SUBJECT:			No:	TSB-18-55-001
TOR	QUE UPDATES: UNI	rs of		
	G TORQUE & NUMER		DATE:	December 2018
FOR HEATER,	AIR CONDITIONING 8	& VENTILATION	MODEL	Soo balaw
-	AIR CONDITIONING A		MODEL	See below
-				See below

This TSB updates the Heater, Air Conditioning & Ventilation section of the affected Service Manuals to correct the tightening torque for the Compressor Assembly.

#### DISASSEMBLY AND ASSEMBLY

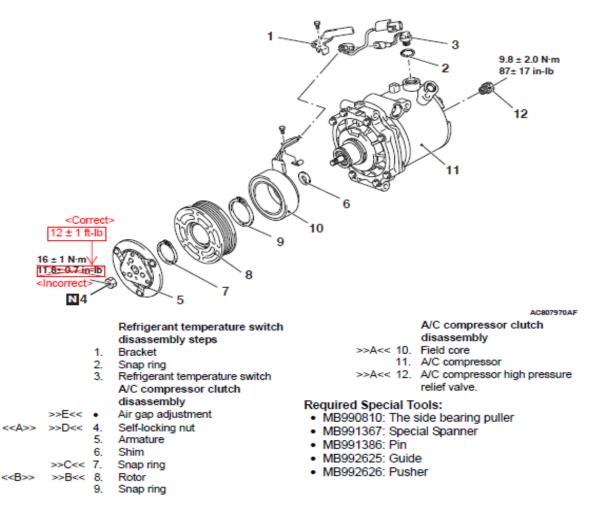
Please make the indicated changes to the 2009 & 2010 Lancer Evolution Service Manual, Group 55 - Heater, Air Conditioning and Ventilation -> Compressor Assembly -> Removal and Installation.
